Serial: HNP-17-001

Shearon Harris Nuclear Power Plant, Unit 1
Docket No. 50-400/Renewed License No. NPF-63

Subject: Summary of 10 CFR 50.54(q) Evaluation

**PEP-241, Technical Support Center (TSC) Emergency Ventilation System Operation,
Revision 6**

Attachment 2 - (Information Use) Technical Support Center Floor Plan Sheet 1 of 1

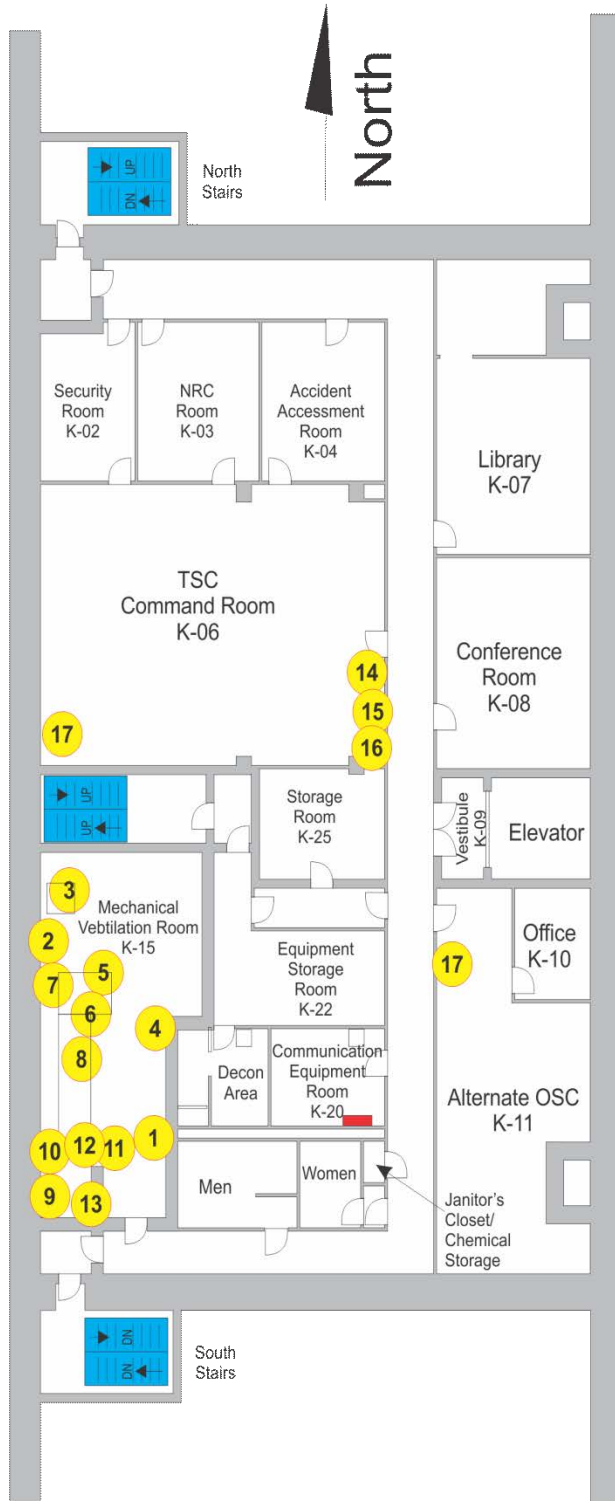
Revision 6 Summary	
Rev. 6 processed with PRR: 2026932 PRRs Incorporated: 1956275 CRs Incorporated: None EC 297736 (Master); 401284 (Child 2), 401286 (Child 3)	
Throughout	[EC 401286] Changed FI-01TS-4000 description from "(Outside Air Intake Fan OA-2 Flow Ind)" to "(Outside Air Intake Fans OA-2 and OA-3 Flow Ind)"
Section 2.0	added EC 401284 (Child2)/EC 401286 (Child 3)/EC 297736 (Master), TSC HVAC Upgrade Project
Step 4.0.1.b	Changed "Ensures actions required..." to "Ensures or initiates actions required..."
Step 4.0.2.b	Deleted step "Takes appropriate actions to resolve TSC Ventilation System problems. (contact OSC for maintenance support, as needed)". This is acceptable since tech has responsibility to notify RCD and RCD has responsibility to ensure/initiate corrective actions.
Step 6.0.4	Added list of TSC boundary doors that are to be monitored.
Section 9.3.1	[EC 401284] Added the following: <u>K-11 Alternate Operations Support Center</u> TIC-1TSC-AH10 (TSC AH-10 Thermostat) <u>K-04 Accident Assessment Room</u> TIC-1TSC-AH11 (TSC AH-11 Thermostat) Updated the following description for TIC-1TSC-AH17: <u>K-06 Command Room</u> TIC-1TSC-AH17 (AH-17 Thermostat) indication

Section 9.4.5	[EC 401284] Added the following: <u>K-11 Alternate Operations Support Center</u> TIC-1TSC-AH10 (TSC AH-10 Thermostat) <u>K-04 Accident Assessment Room</u> TIC-1TSC-AH11 (TSC AH-11 Thermostat) Updated the following description for TIC-1TSC-AH17: <u>K-06 Command Room</u> TIC-1TSC-AH17 (AH-17 Thermostat) indication
Attachment 1	[EC 401286] Revised Normal alignment From: 2. Verify 1TSC-E003:003 (OA-2 Motor Starter Hand Switch) ⁽²⁾ is ON. 3. Verify DS-1TSC-E003 (Disconnect Switch for OA-2) ⁽²⁾ is ON. 4. Check 1TSC-E003 (Outside Air Intake Fan OA-2) ⁽³⁾ is operating. To: 2. IF 1TSC-E003:003 (OA-2/OA-3 Motor Starter Hand Switch) ⁽²⁾ is in OA-2 position, THEN verify the following lineup: a. DS-1TSC-E003 (Disconnect Switch for OA-2) ⁽²⁾ is ON. b. 1TSC-E003 (Outside Air Intake Fan OA-2) ⁽³⁾ is RUNNING. c. 1TSC-E067 (Outside Air Intake Fan OA-3) ⁽³⁾ is OFF. 3. IF 1TSC-E003:003 (OA-2/OA-3 Motor Starter Hand Switch) ⁽²⁾ is in OA-3 position, THEN verify the following lineup: a. DS-1TSC-E067 (Disconnect Switch for OA-3) ⁽²⁾ is ON. b. 1TSC-E067 (Outside Air Intake Fan OA-3) ⁽³⁾ is RUNNING. c. 1TSC-E003 (Outside Air Intake Fan OA-2) ⁽³⁾ is OFF.
